STAFF REPORT
(Preliminary Plat)

CASE NUMBER: S/D 99-78 -- HARRISON INDUSTRIAL ADDITION

STAFF REPORT
(Final Plat, Preliminary Plat Approved 12/2/99)

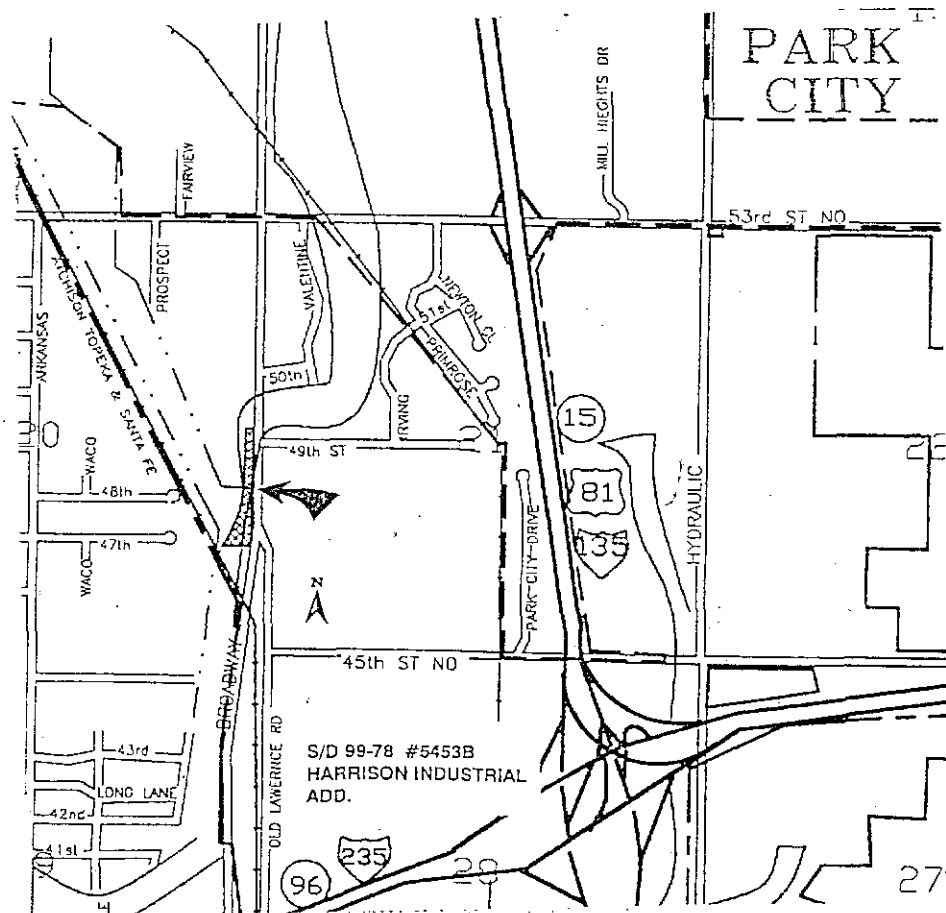
- A. Since sanitary sewer is unavailable to serve this property, the applicant shall contact the Environmental Health Division of the Health Department to find out what tests may be necessary and what standards are to be met for approval of on-site sewerage facilities. A memorandum shall be obtained specifying approval. The Applicant proposes a storage use for the site, requiring no additional on-site sewage disposal.

- D. County Engineering needs to comment on the status of the applicant's drainage plan.
- E. County Engineering needs to comment on the need for access controls. On the final plat, the dedication of access controls shall be referenced in the plat's text. The Subdivision regulations encourage shared access points for multiple lot industrial subdivisions along arterials. County Engineering requests the dedication of additional right-of-way.

- F. The recording data and location of the pipeline shall be included on the face of the plat.
- G. The designation of Broadway as U.S. Highway 81 shall be removed.

- I. The plat's text shall include language that a drainage plan has been developed for the plat and that all drainage easements, rights-of-way, or reserves shall remain at established grades or as modified with the approval of the applicable City or County Engineer, and unobstructed to allow for the conveyance of stormwater.
